Re: Section 4.55(2) Modification SSD 7942 Pod B, P5 Car Park, Hill Road, Sydney Olympic Park (Lot 71 DP 1191648)

Please find enclosed the applicant's response to the submissions (RtS) to the exhibition of the subject modification application. This RtS prepared by Urbnsurf responds to the items identified by the Department of Planning, Industry and Environment (DPIE), as well matters raised in submissions from agencies and the general public. The RtS is supported by the following information:

SECTION 1.0 – AUTHORITY & ORGANISATION – RESPONSES TO SUBMISSIONS

RE: Tree Removal

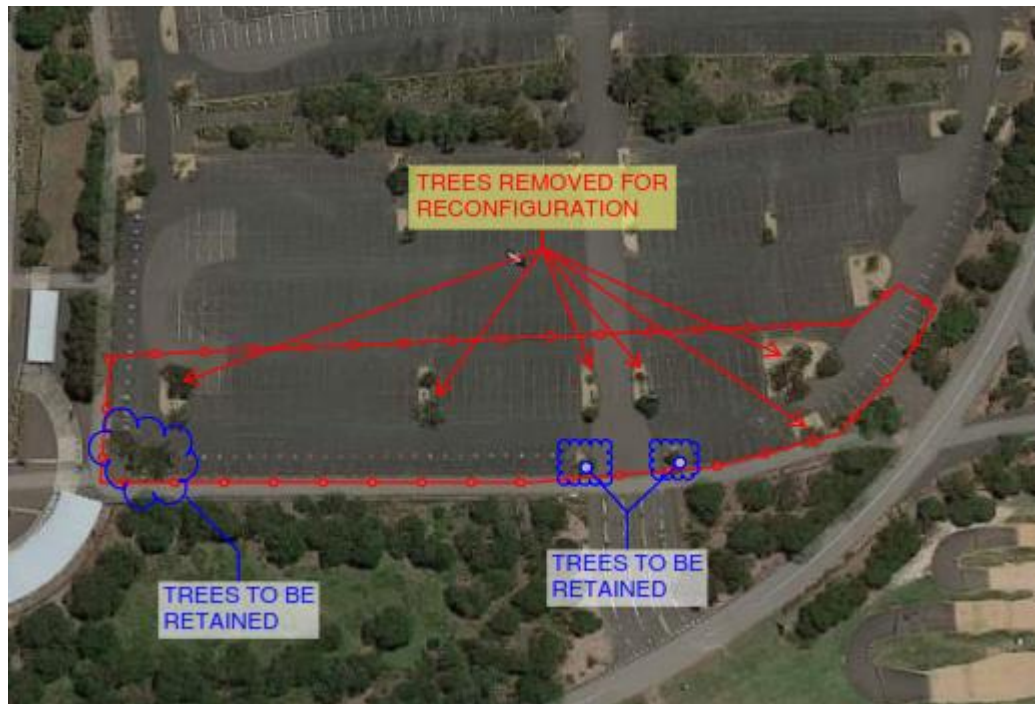
SOPA considers that the removal of the eight trees in the car park to the south of the site to facilitate additional car parking is not justified in this instance. The proposal already includes significant tree loss to facilitate the wave park. Whilst the loss of trees were considered justified in the assessment of the original SSD, the removal of eight additional trees in this modification to facilitate additional car parking without significant off-set or retention is contrary to current and draft policies for Sydney Olympic Park, Greater Sydney and NSW. Of note, the following policies are relevant and should be taken into consideration in the assessment and justification of this SSD modification:

The proponent should seek to adopt a maximum tree retention methodology for the car park and review the car-parking layout to maximise tree retention. Furthermore, the removal of any additional trees at the site should be fully supported by an Arborist Report and where tree retention is unavoidable; replacement tree planting measures should be detailed.

Our understanding is an additional twelve trees have been added to the landscape plan. These trees will be planted in beds within the car park that wraps around the south and south eastern perimeter of the site. Removal is necessary to accommodate the current carpark configuration. Four trees have been retained in this area (see figure overleaf). The trees that are proposed for removal have little ecological value. Generally, the vegetation throughout the study site is in poor condition, lacking the normal structural components such as a shrub layer and a comprehensive understorey layer. This is not surprising given the history of the site. As well, many of the trees on site, at the time of site inspections, showed signs of stress that probably resulted from their location in the middle of a hot, dry, windy, sealed carpark.

Subject: Key Summary of amendments between S4.55 set (Rev a, dated 12/03/2021) and amended plans (Rev b, dated 30/06/2021)

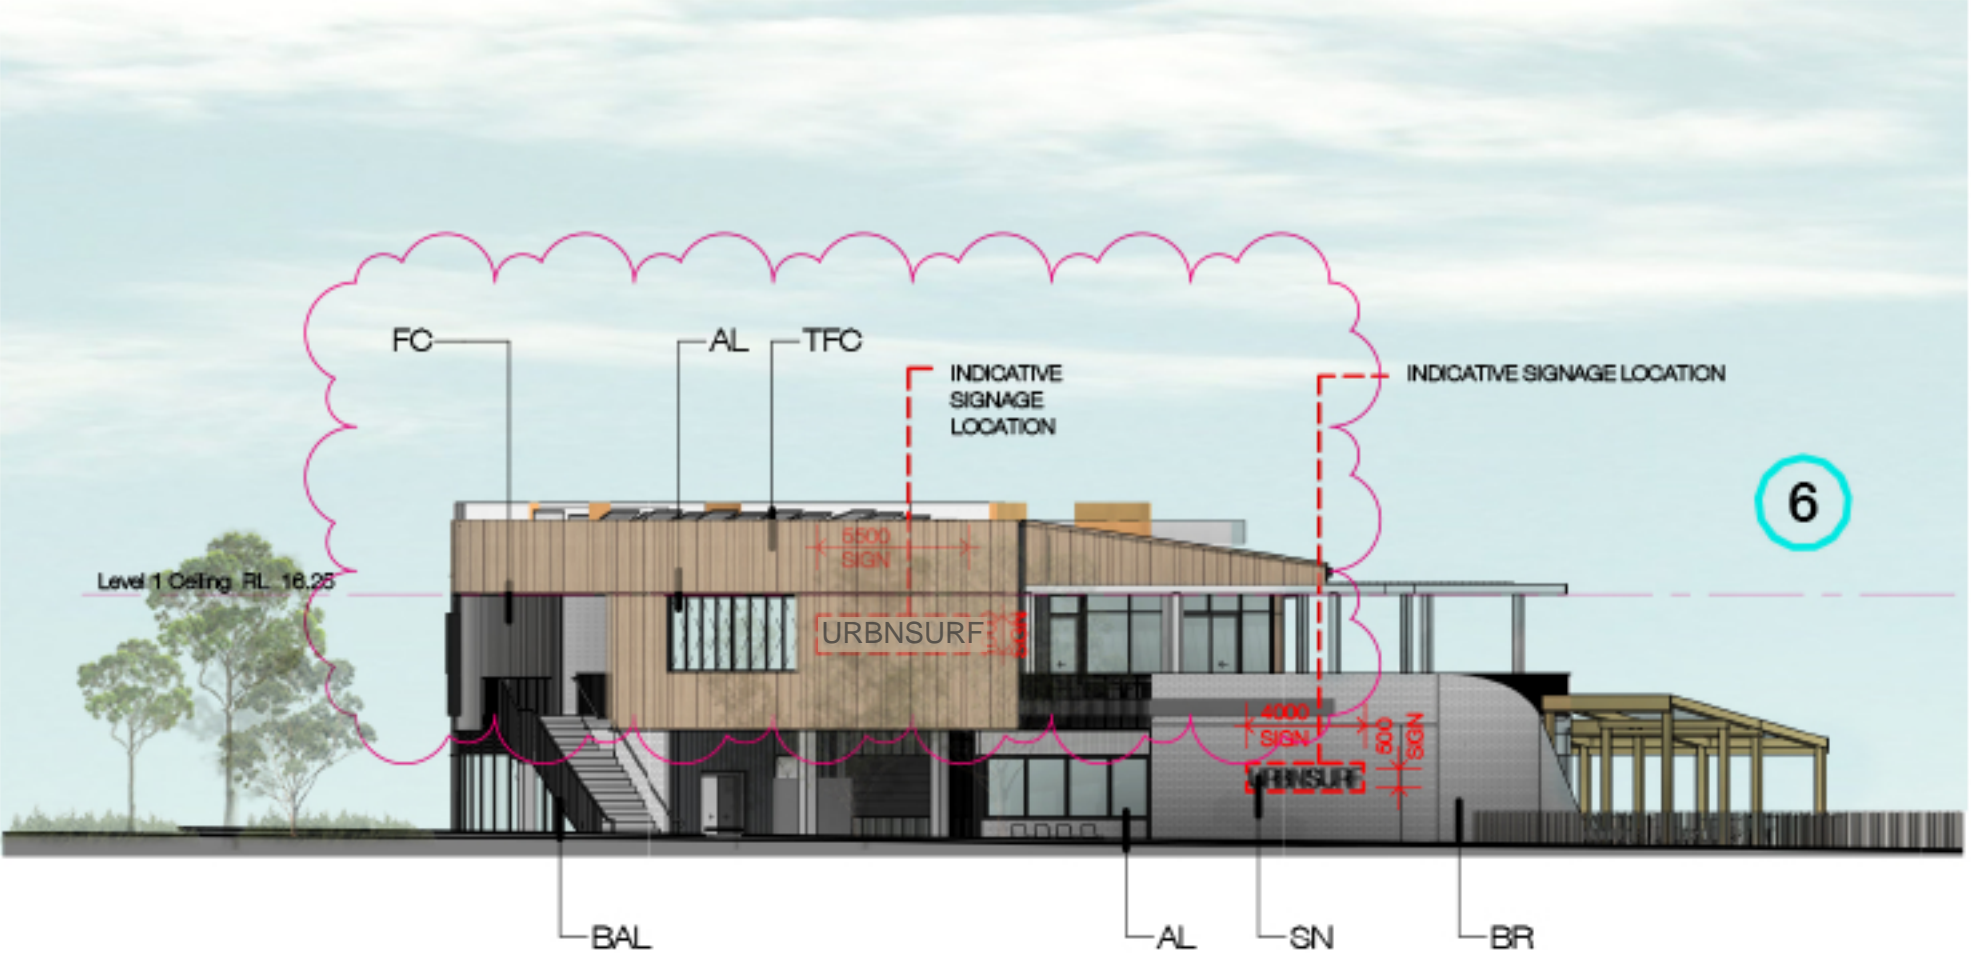
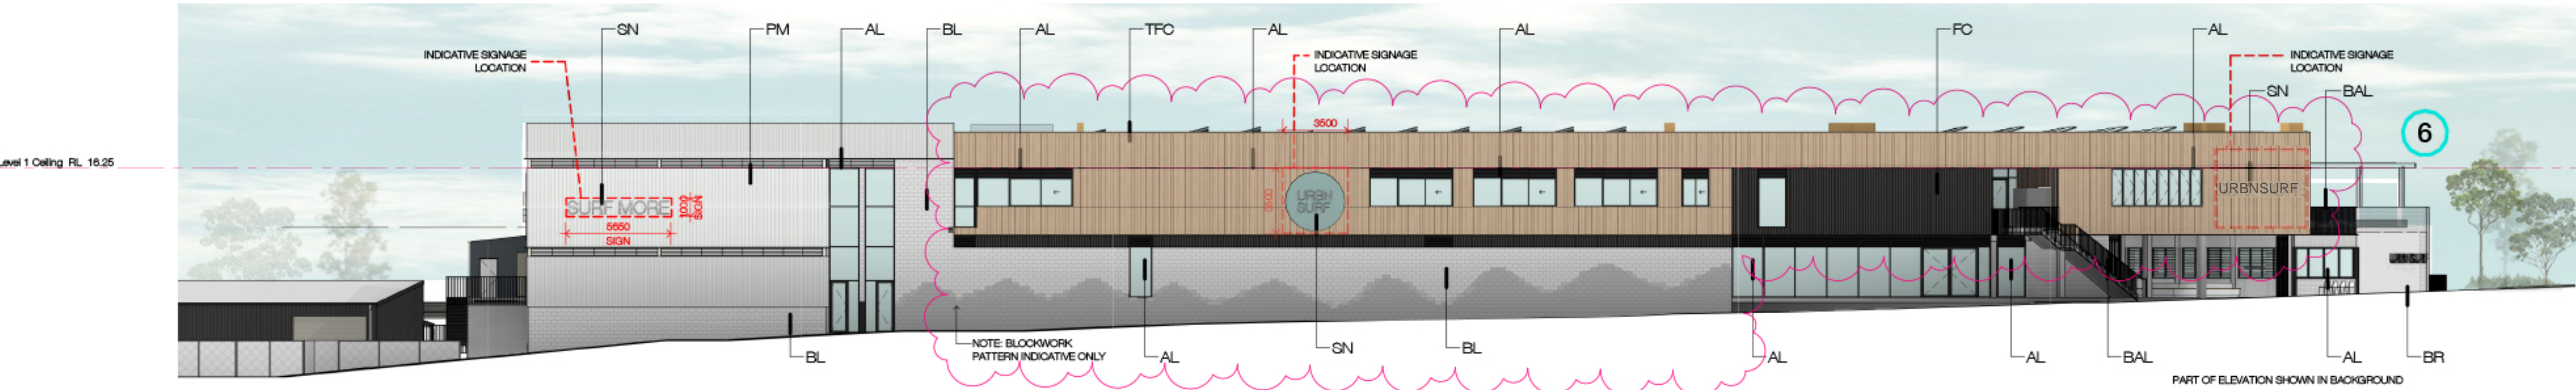
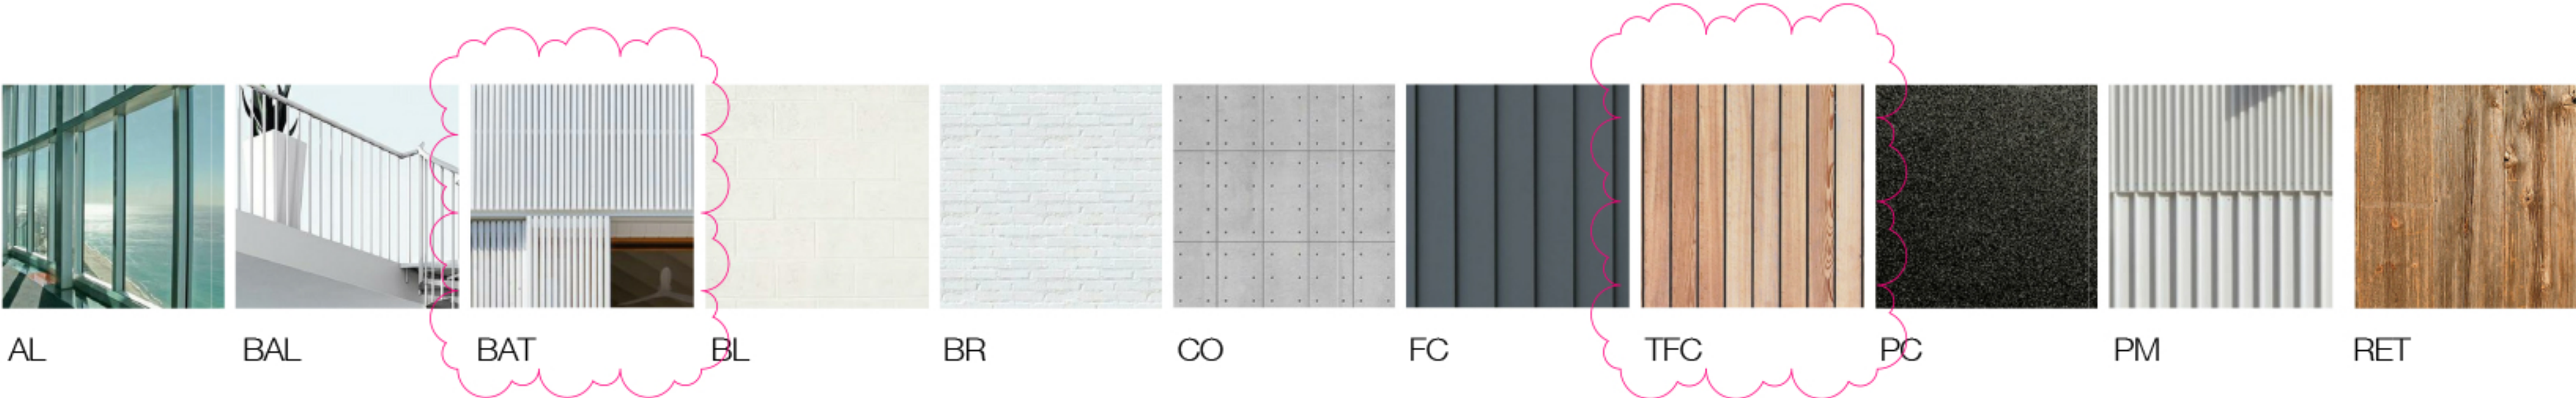
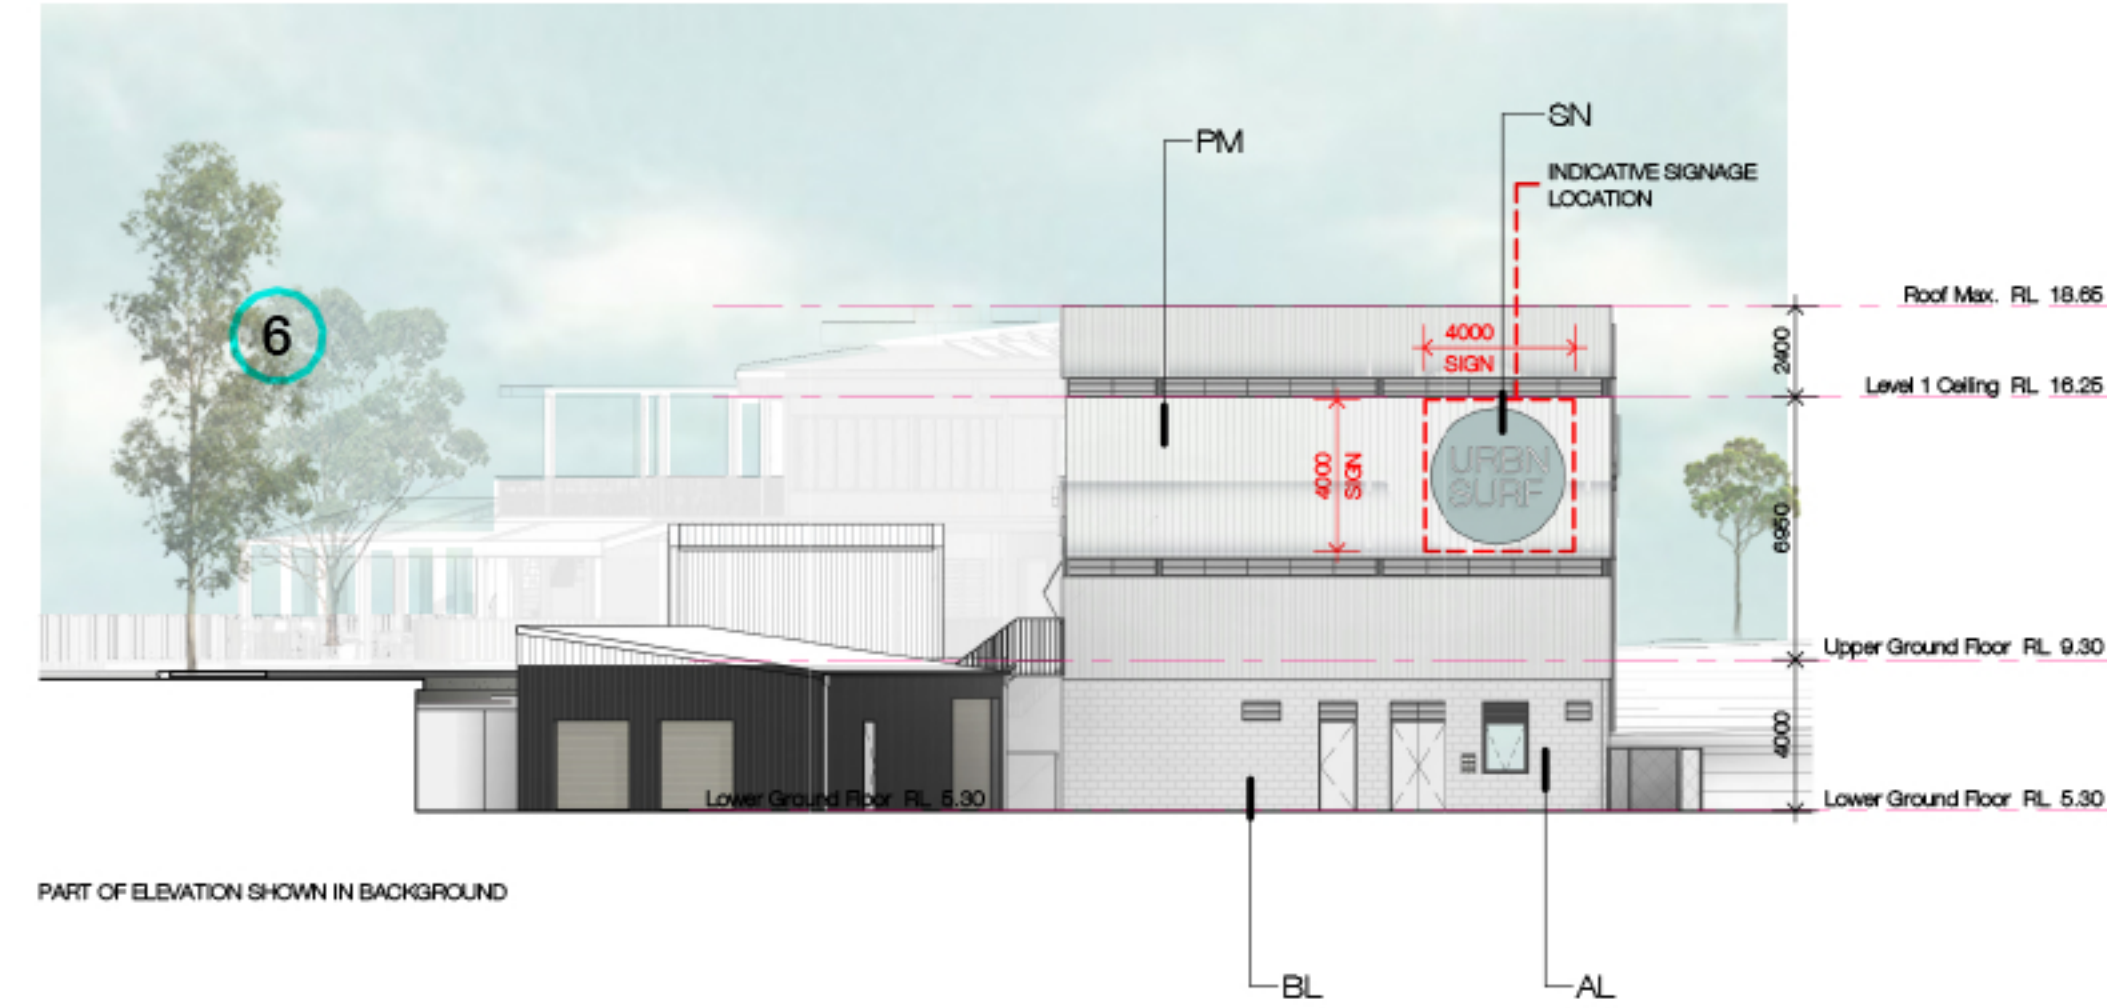
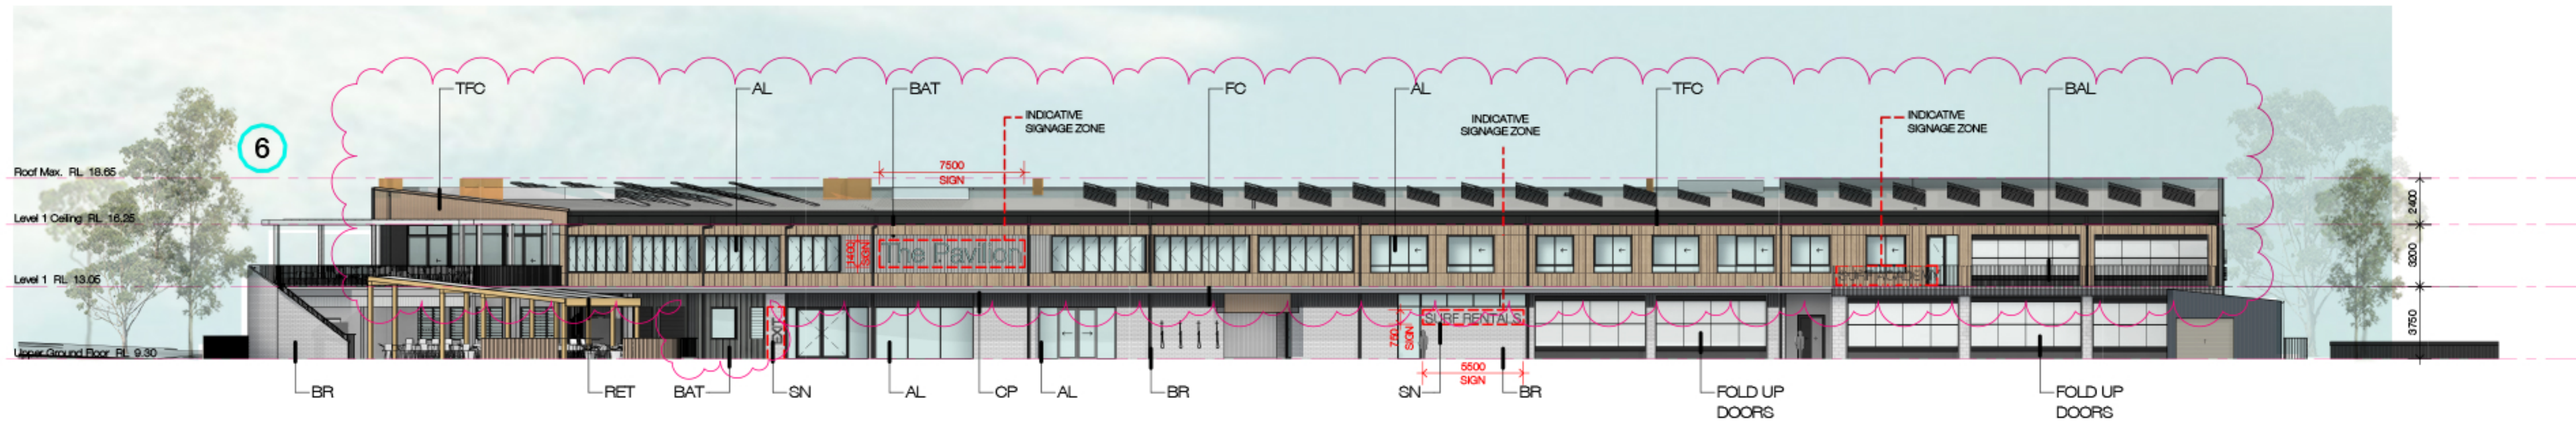
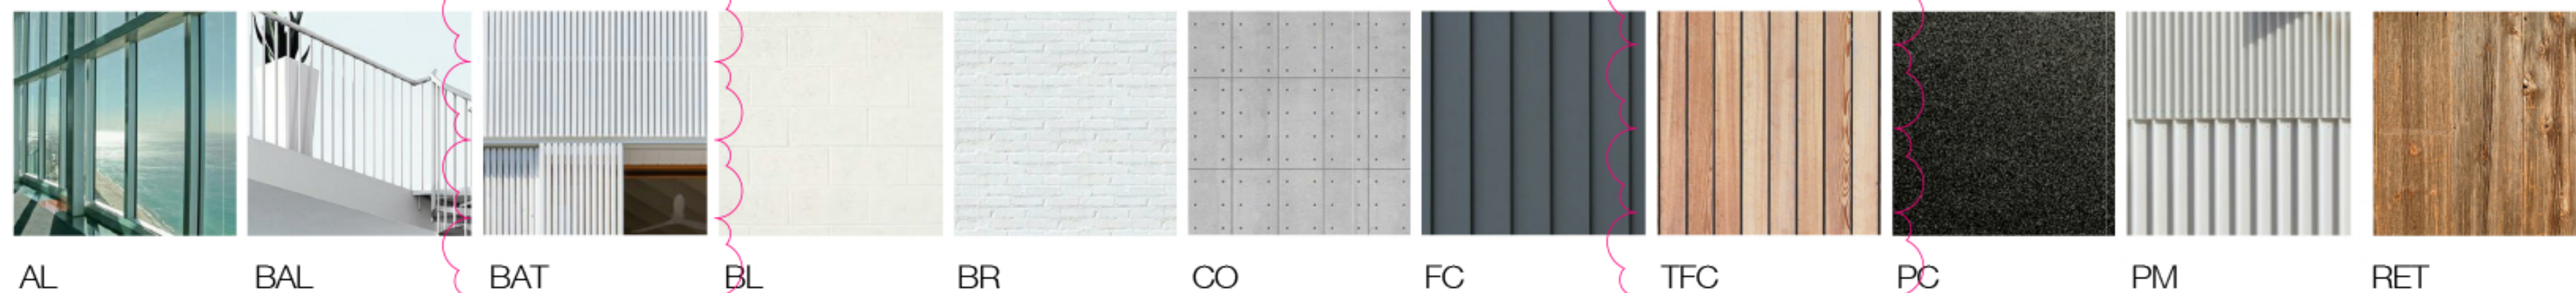
R07	SOPA	<p>Design Modifications</p> <p>SOPA considers that the modifications to the approved development will continue to incorporate an acceptable building form and massing appropriate to development within Sydney Olympic Park.</p> <p>However, SOPA considers that the materiality and colour of the proposed building facade, given the location of the development site within Sydney Olympic Park Parklands, should be more reflective of the site’s location and incorporate natural materials and neutral colours. In particular, the dark tones and large amounts of the proposed modified cladding and loss of the warm-toned timber cladding is not appropriate to the setting.</p> <p>Moreover, the SOPA Design Review Panel Advice Sheet (2 February 2017) for the original SSD notes the following positive aspects of the proposed design:</p> <ul style="list-style-type: none"> - ‘Breezy, permeable relaxed’ concept approach and use of sustainable materials is generally supported; and - The facility has a good visual fit with in the established native parkland setting as ‘built forms in landscape’. <p>Further SEPP SPP, Clause 30 Design Excellence, requires that the consent authority considers whether a proposal exhibits design excellence, having regard to:</p> <ol style="list-style-type: none"> a) whether a high standard of architectural design, materials and detailing appropriate to the building type and location will be achieved; and b) whether the form and external appearance of the building will improve the quality and amenity of the public domain, <p>Accordingly, SOPA considers the modified design in relation to materials and colours of the façade are unacceptable and the original colours and materials should be revisited.</p>	<p>Design Materiality</p> <ul style="list-style-type: none"> - The Proponent acknowledges the comments regarding the materiality and colour palette of the façade and confirms the following: <ul style="list-style-type: none"> o The Type A construction classification of the building prohibits the use of flammable materials on the building façade. Timber and other natural materials are unable to be specified as a result of this classification. o To achieve consistency with the comments raised by the SOPA Design Review Panel, updates have been made to the colour palette of the building façade, as well as the texturing or brick and blockwork patterns. This is able to be achieved via advanced staining techniques in combination with non-flammable façade batten panels. o Clarke Hopkins Clarke the project architect has provided updated renders and building materiality elevation plans to highlight the key changes. o The project Architect has included a letter to provide context on the updates and commentary on the consistency with the comments expressed by the SOPA Design Review Panel. <i>Please refer: Appendix 7 - A-USS-S.455_Architectural Amendments.</i>

In response to the comments on design modifications, we have revised the materiality of the built form.

In keeping with the concept of creating a coastal village aesthetic, we have proposed to maintain the lighter textural elements of the white bagged brickwork and blockwork, primarily on the ground plane. We have replaced the darker cladding elements on the lower section of the south-western façade with blockwork and have proposed to implement a pattern with colour variation to promote a natural movement within the façade.

SHEET NUMBER	SHEET NAME	AMENDMENT	NOTES
All Drawings			
DA.25	Proposed GA Elevations	<i>Updated elevations to reflect change of materiality</i>	Reflects Key Change 1,2.
DA.26	Proposed GA Elevations	<i>Updated elevations to reflect change of materiality</i>	Reflects Key Change 2,3.
DA.30	External Materials Schedule	<i>Updated material schedule to include materiality updates</i>	Reflects Key Change 2,3.
DA.31	3D Concept Imagery - Overall Site	<i>Replaced 3D image to reflect change of materiality</i>	Reflects Key Change 2,3.
DA.32	3D Concept Imagery - Entrance	<i>Replaced 3D image to reflect change of materiality</i>	Reflects Key Change 2.
DA.33	3D Concept Imagery - Food & Beverage	<i>Replaced 3D image to reflect change of materiality</i>	Reflects Key Change 2.
